Metropolitan  
St. Louis Sewer  
District

Re: Sewer Connections in the Combined Sewer Area (City of St. Louis and Inner Suburb Areas)

October 7, 2005

Please see the attached letter and sketches. Note these two attached sketches are revised versions of the original sketch dated July, 2005. Please discard the sketch dated July, 2005 and use these instead. No major changes were made, but these are being reissued for further clarification. The "No Basement Fixtures" scheme (sheet 2 of 2) was added to show that no **sanitary** pump is required if no basement plumbing for sanitary fixtures is proposed (no basement sinks, toilets, rough-ins, washing machine, etc.)

**FIGURE 3-2  
TYPICAL STRAPPED  
PLUMBING INSTALLATION  
(NO BASEMENT FIXTURES)**

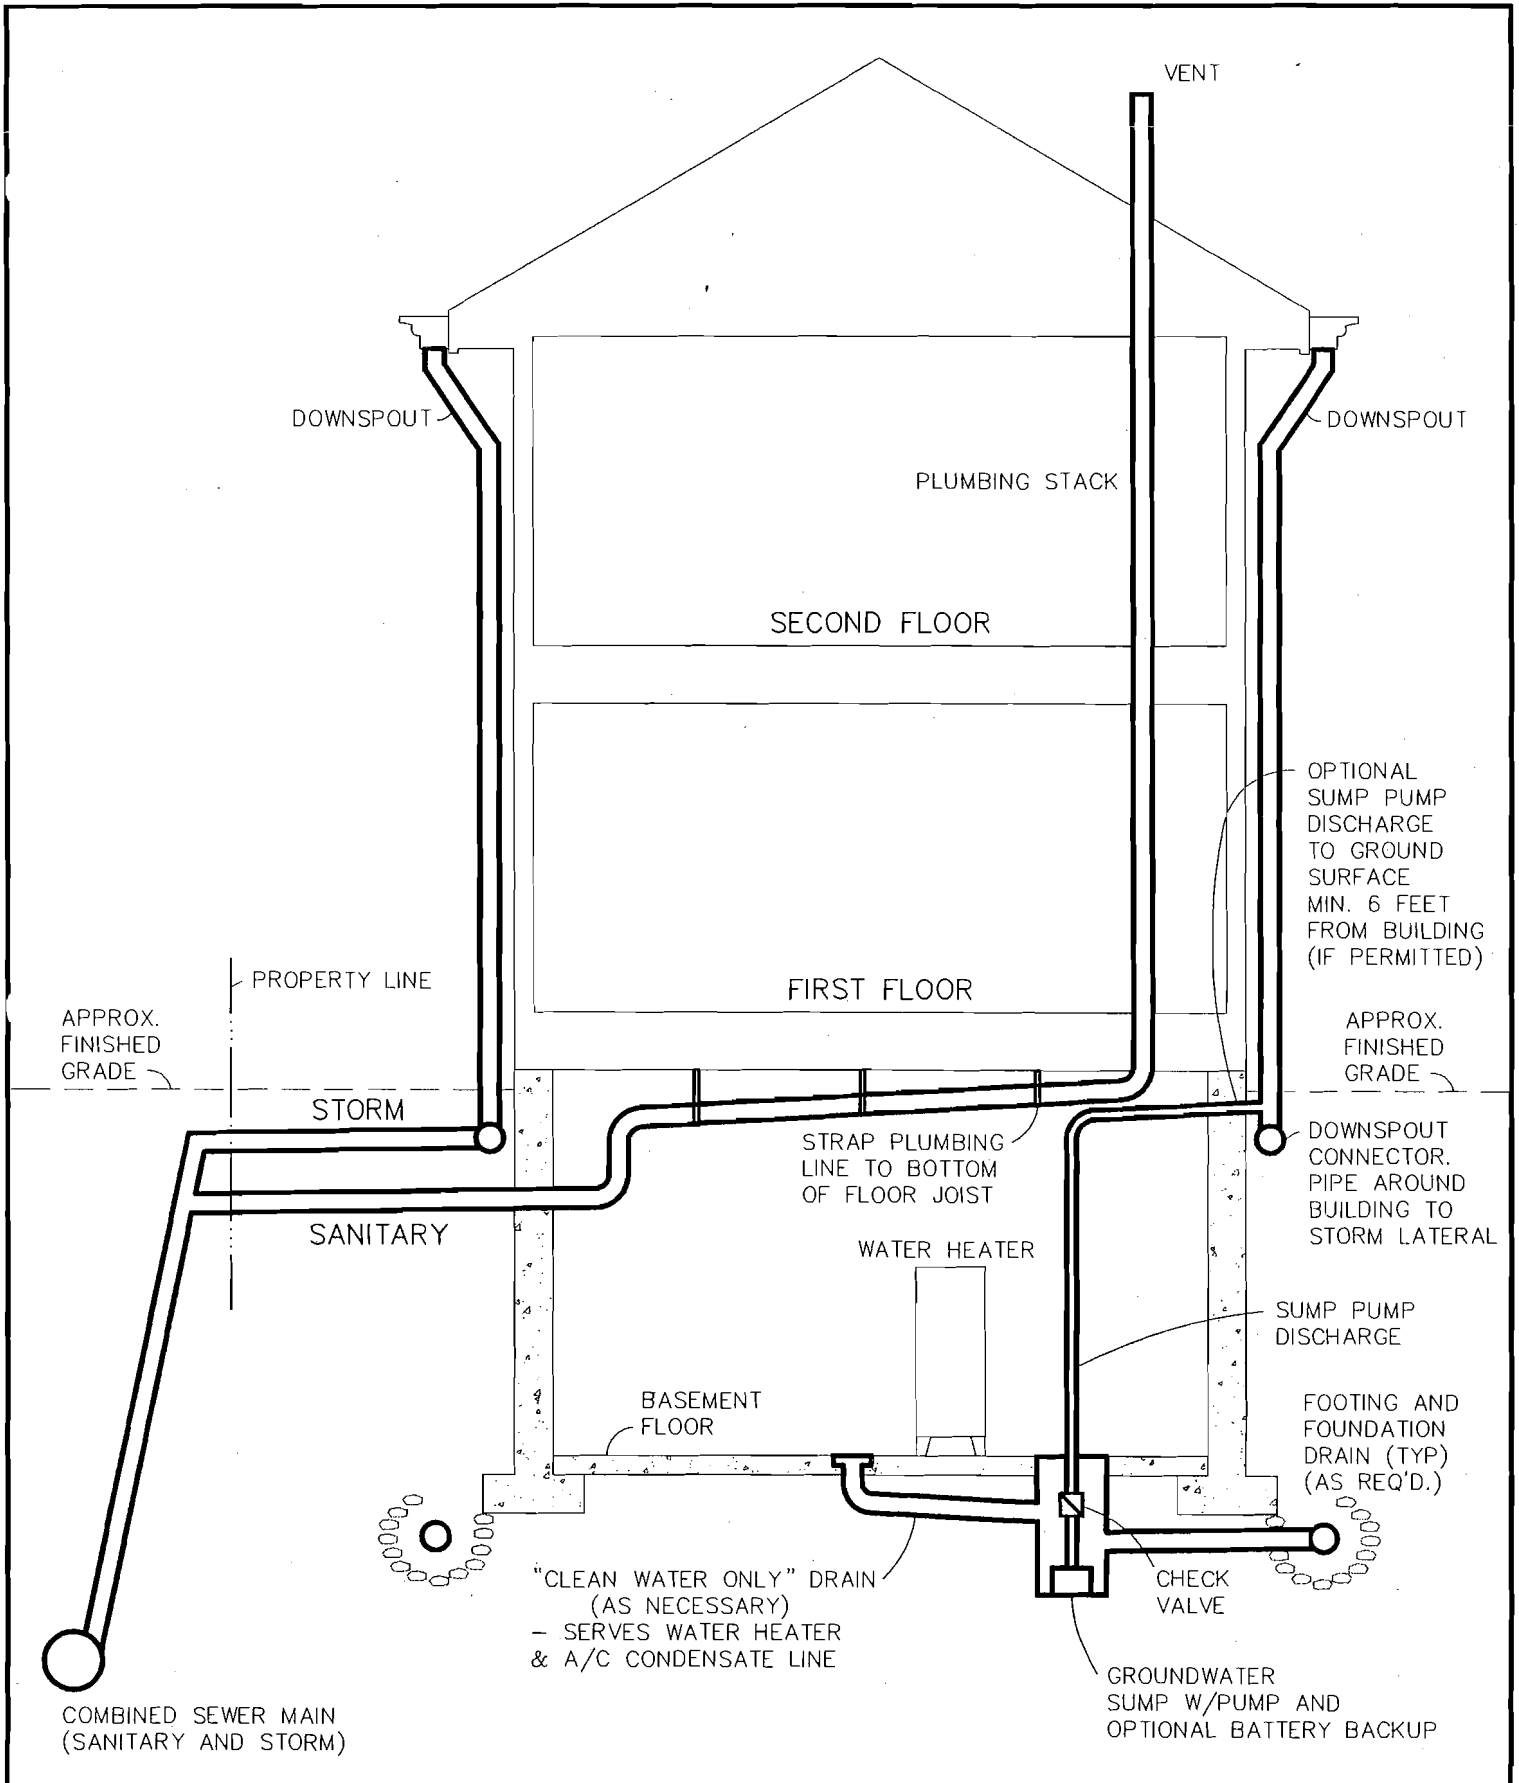
A floor drain for "**clean water only**" that is connected to the **storm** sump pit has been shown on sheet 2 of 2. This would serve as an emergency drain for the water heater, and also as a drain for an air conditioning condensate line.
